ADDENDUM 02

07/17/2025

**RE: Woodland JUSD Transportation Bus Charging
Studio W Project Number: 24047**

CIVIL SITE LAYOUT

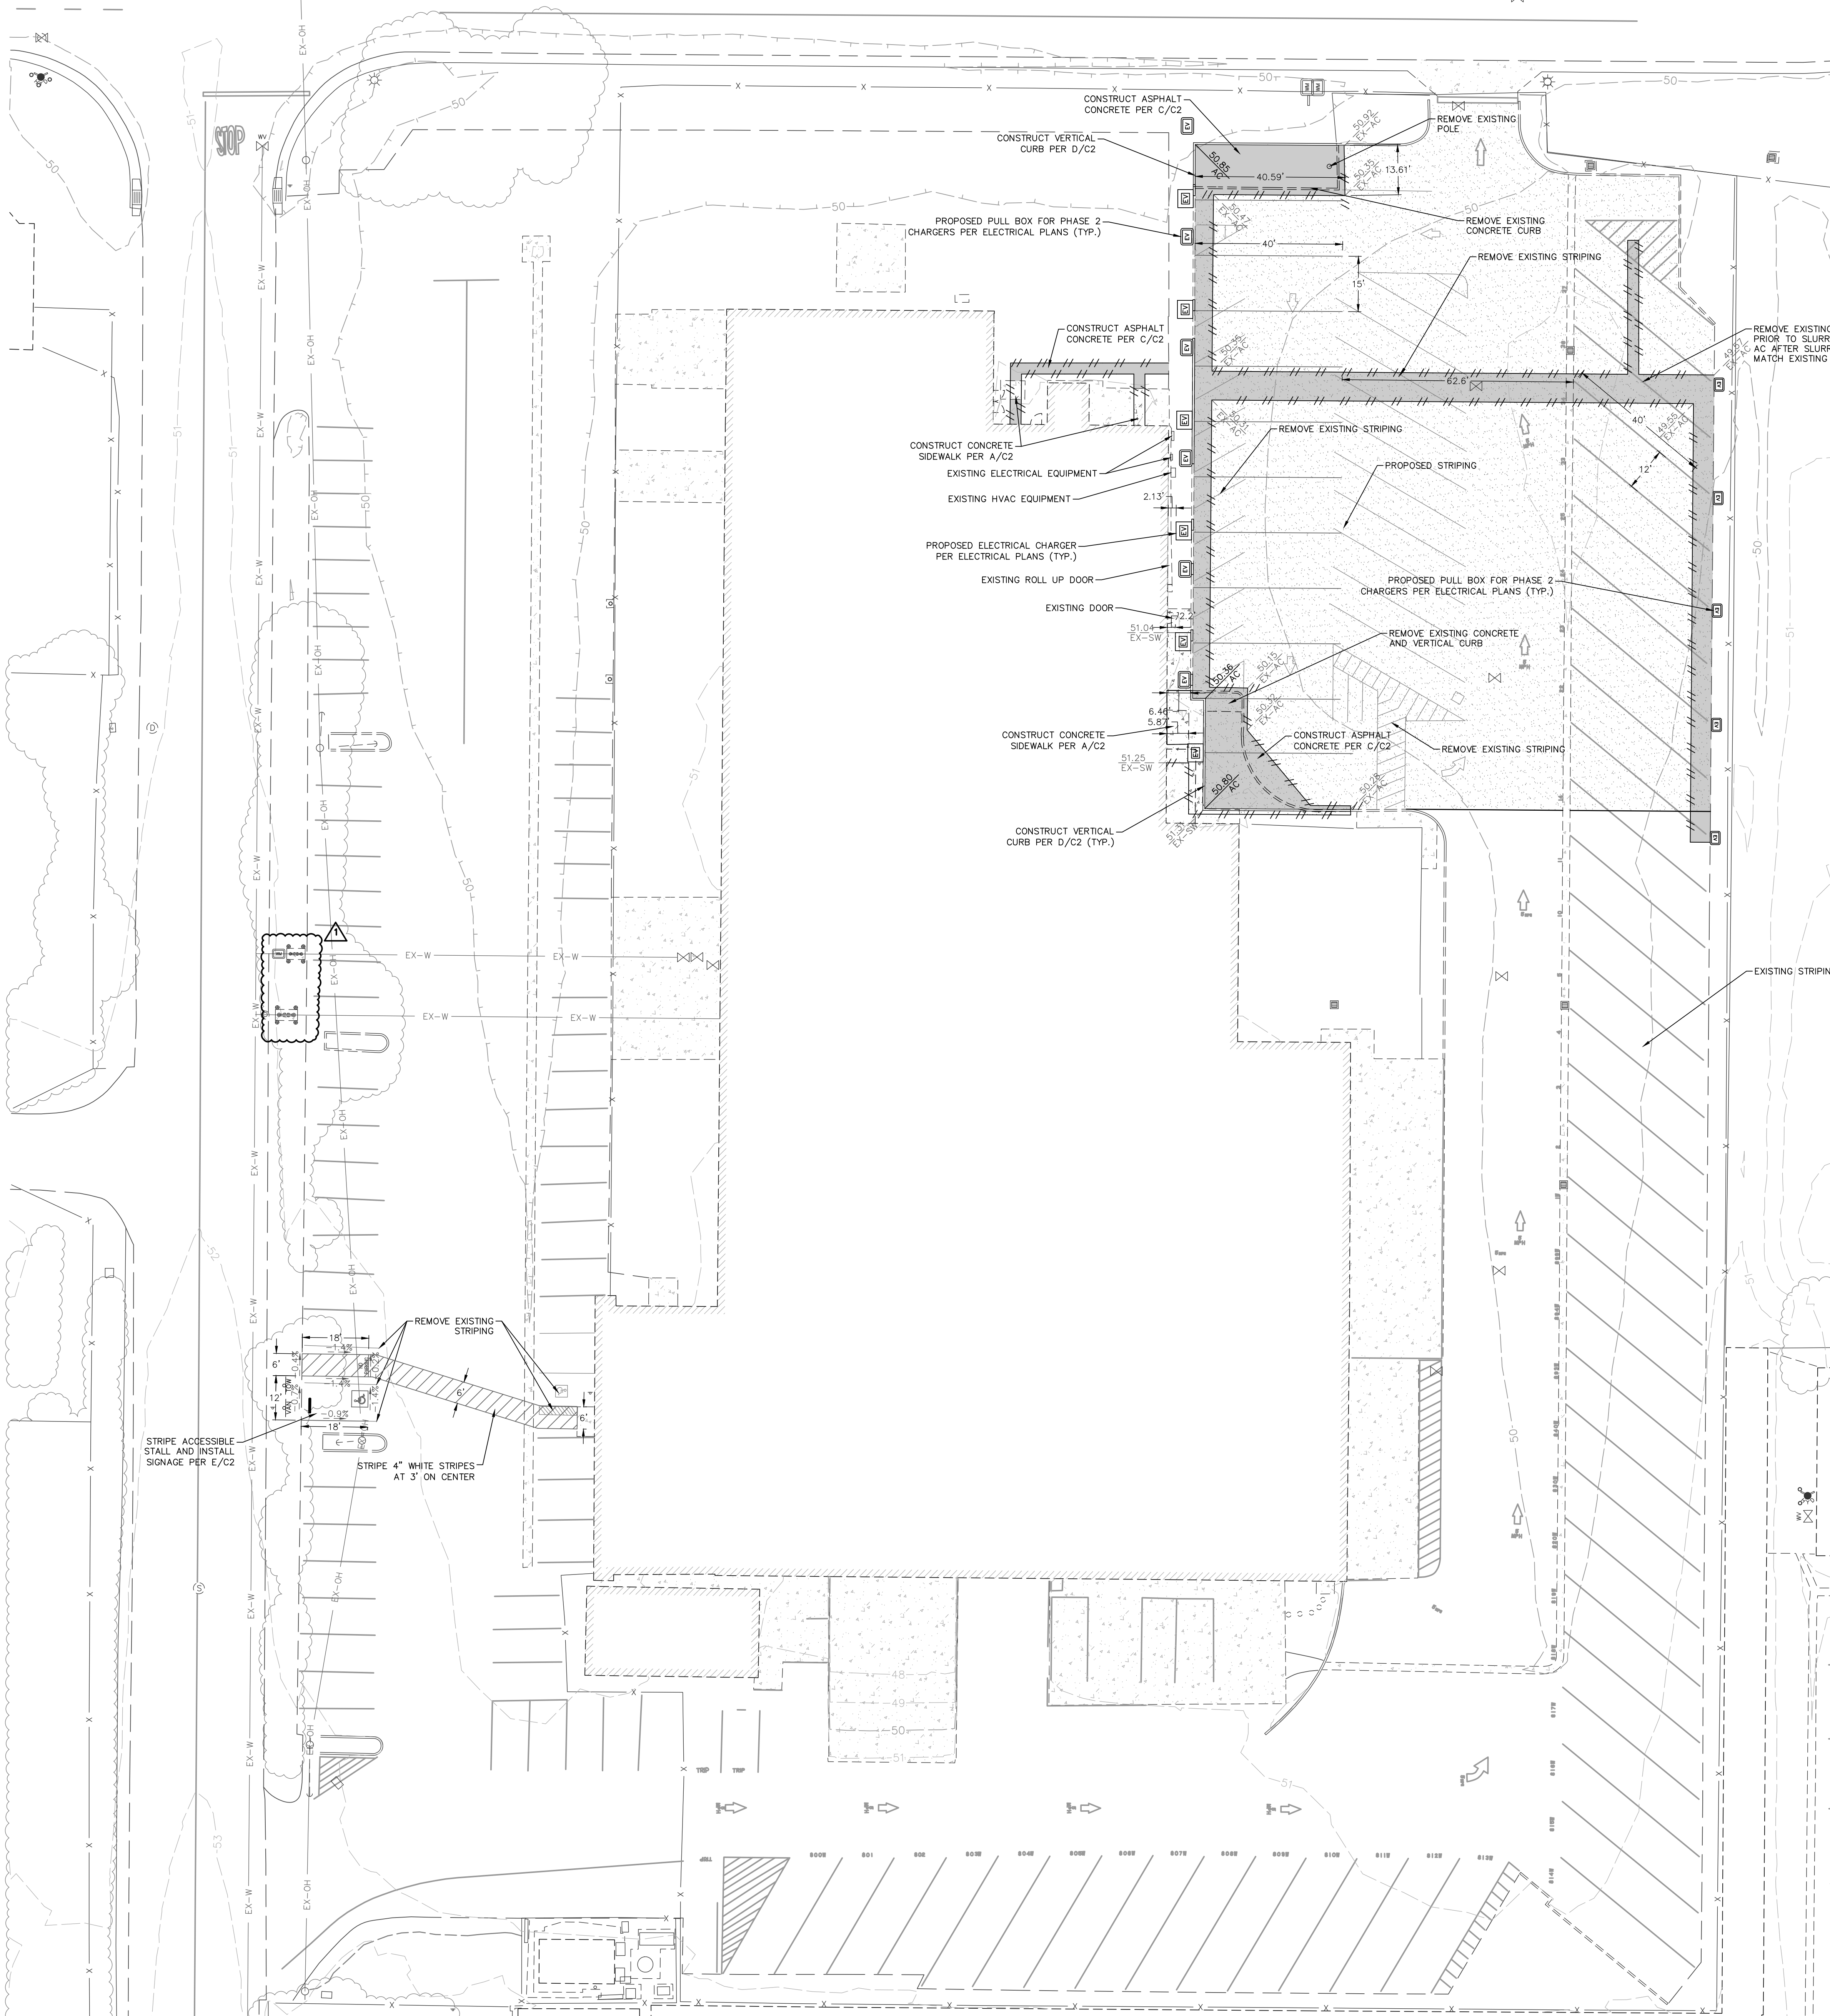
Q1: Sheet C1 Shows some Civil Work. Is this Civil Work part of the Bid package? Specifically

Q1.1: 8" Fire Backflow Preventer, If so, does it tie into exiting piping.

- C1
 - 1. Added demolition note regarding underground utility locating
 - 2. Removed fire back flow preventor from scope of work
- C2
 - 1. Omitted detail 0761 Backflow Prevention Assembly: Smaller than 3" Dia.
 - 2. Omitted detail 0762 Fire Department Connection

1. CONTRACTOR TO PERFORM UNDERGROUND UTILITY LOCATING PRIOR TO ANY SITE DEMOLITION.

A1.1: 8" fire backflow preventor has been removed from scope of work, see revised civil drawings in this addendum

SINGLE LINE DIAGRAM AND PANEL SCHEDULES

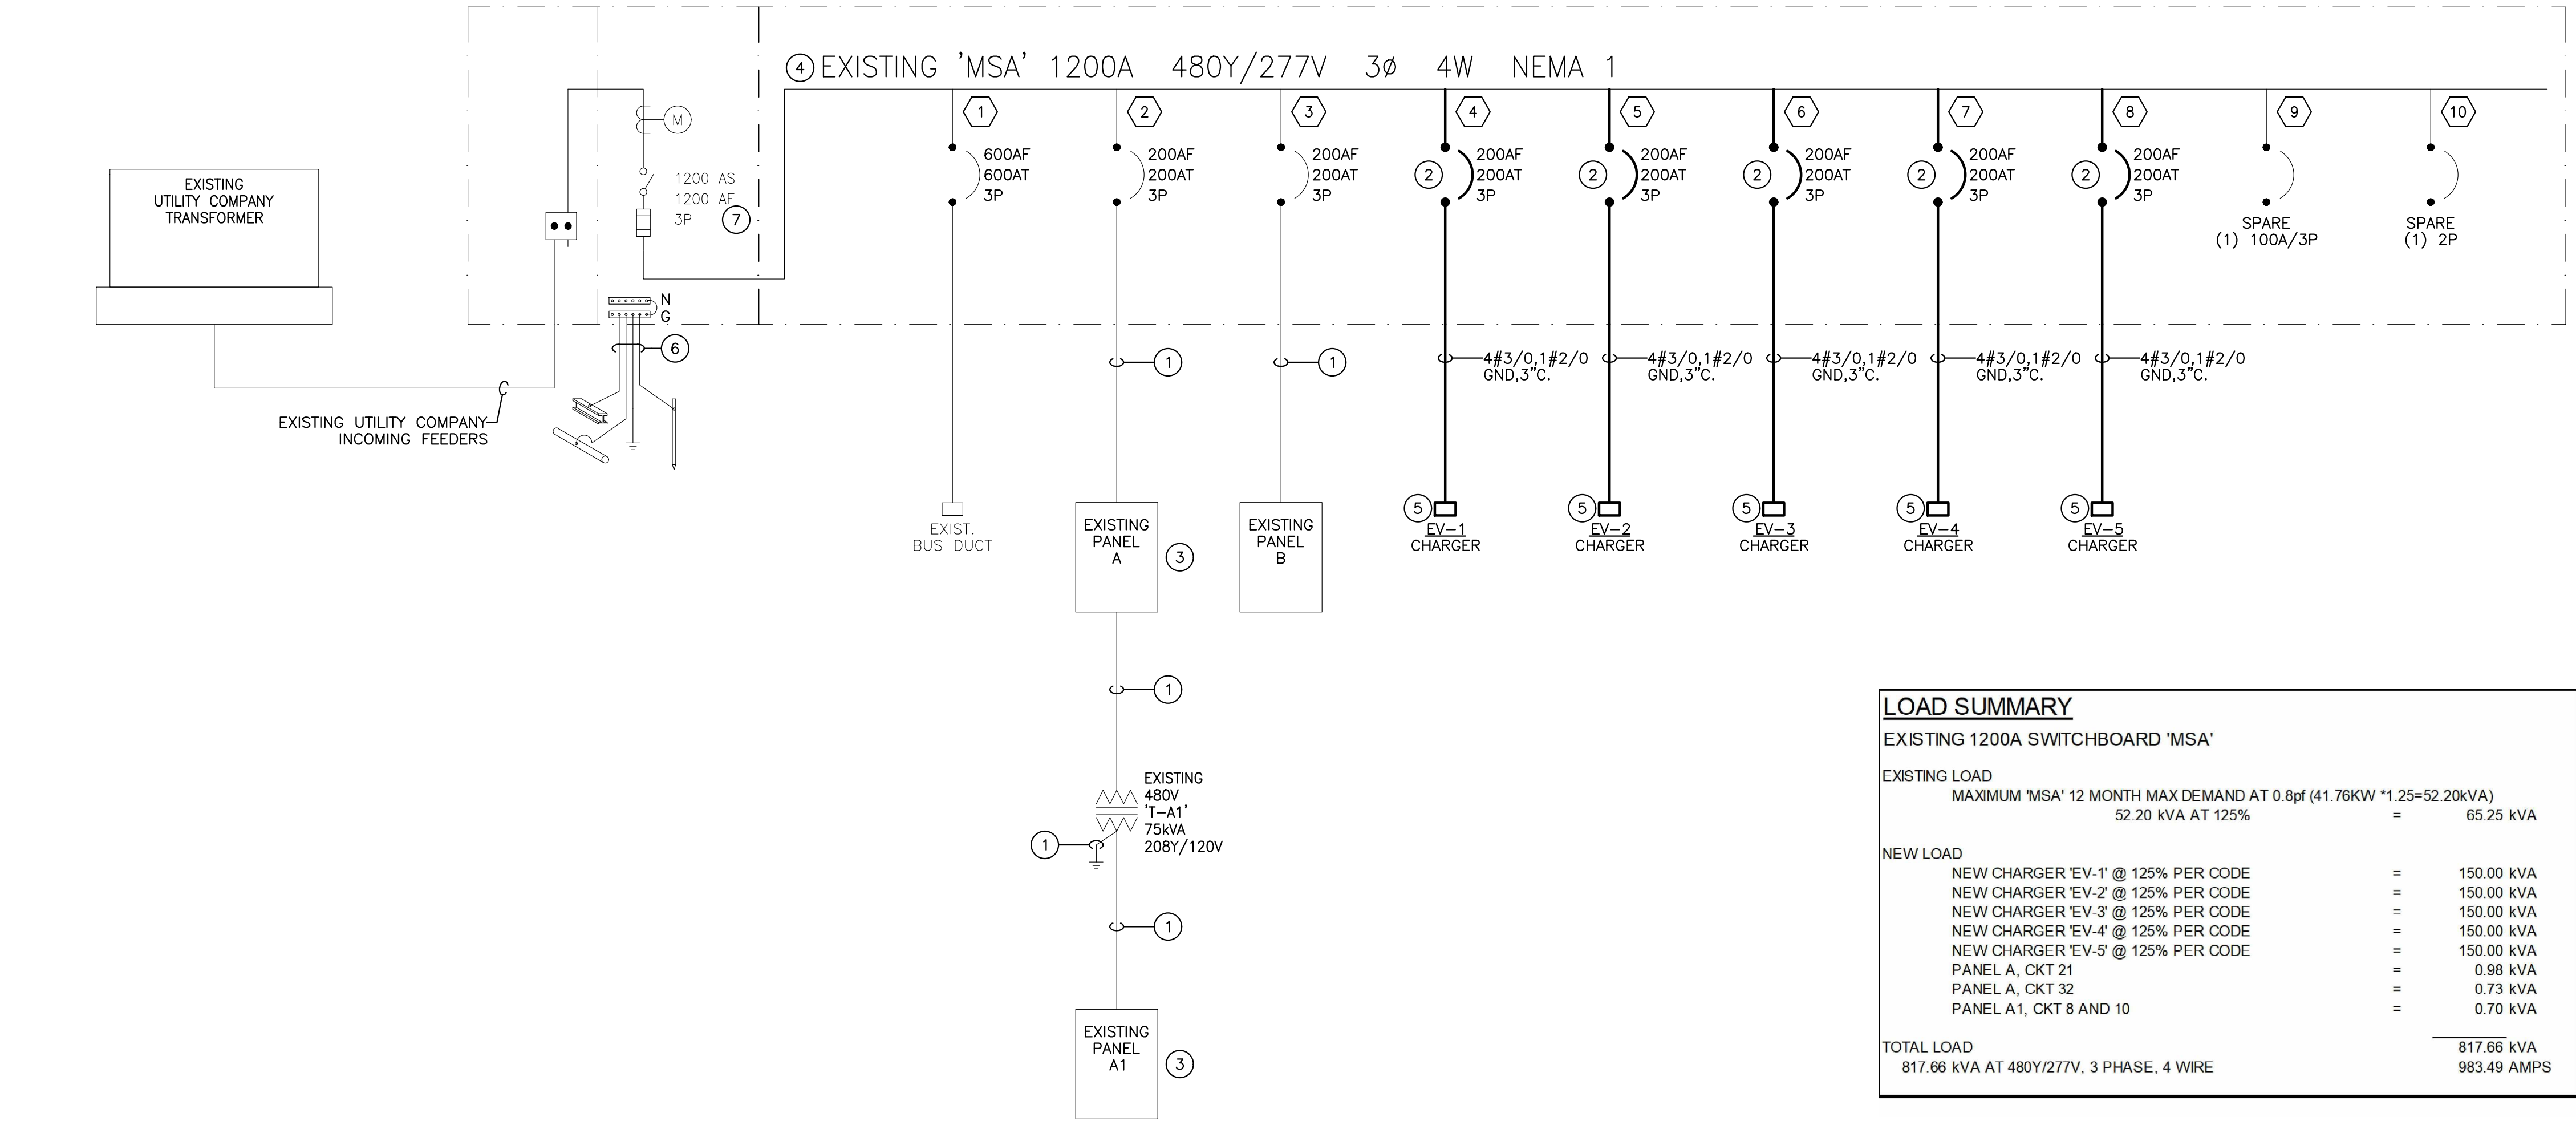
- E4.1
 - 1. Modified keynote 5 for EV charging station to be owner furnished, contractor installed
